TMC SPECIFICATION NO. S -591

TITLE: UNSYNTHEZIZED GPT-10K and GPT-40K ALDC

MODIFICATION KIT (TMC NO. KIT-111)

To provide ALDC from transmitter to exciter units in auxilliary frame.

FIGURE 1

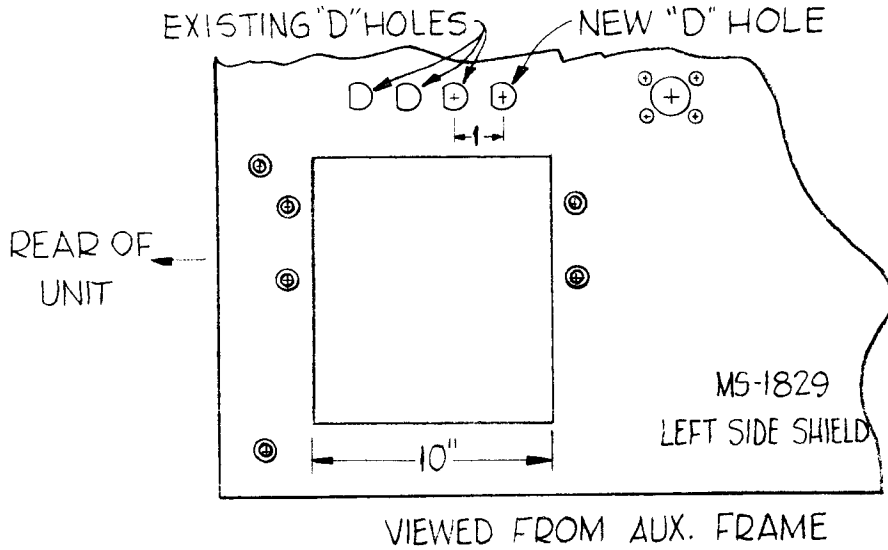
1. Remove all AC power from transmitter.
2. Disconnect cables from IPA unit in main frame and remove unit from transmitter.
3. Referring to Figure 1, Drilling Plan, Left Side Shield, MS-1829, mark location of new "D" hole. Drill a 5/16 dia. hole with item 5. Punch a "D" hole with item 4.

FIGURE 2

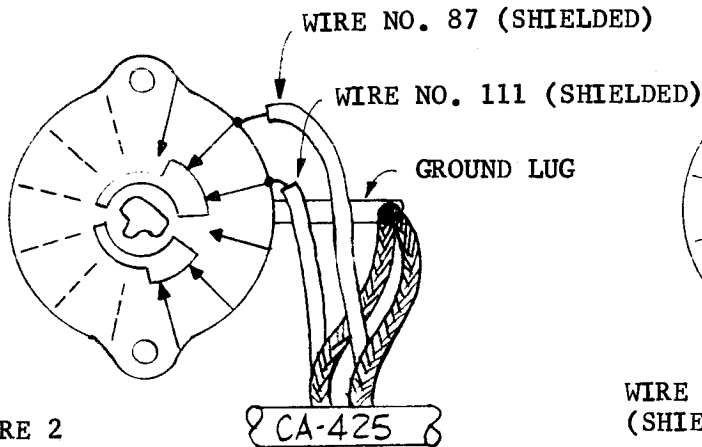
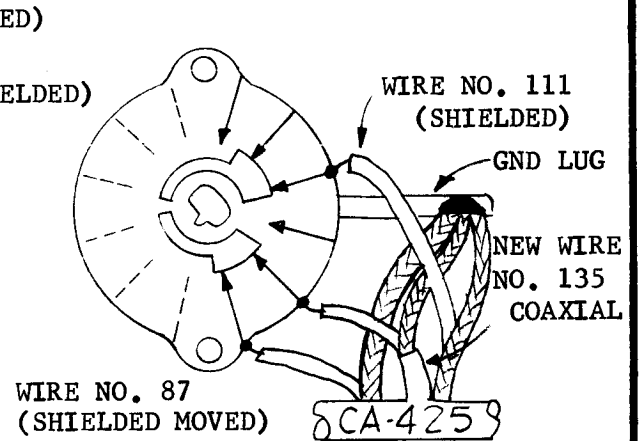
6. Rewire ALDC switch, symbol No. S1003, as per Figure 2., and make continuity check for proper operation.
7. Referring to Figure 3, Drilling Plan, Auxilliary Frame Center Panel, MS-1847, mark location of new "D" hole. Drill a 5/16 dia. hole with item 5. Punch a "D" hole with item 4.

AX-113, MAIN POWER PANEL CHANGE WIRING OF ALDC SWITCH,
SYMBOL S1003 PART No. SW-255
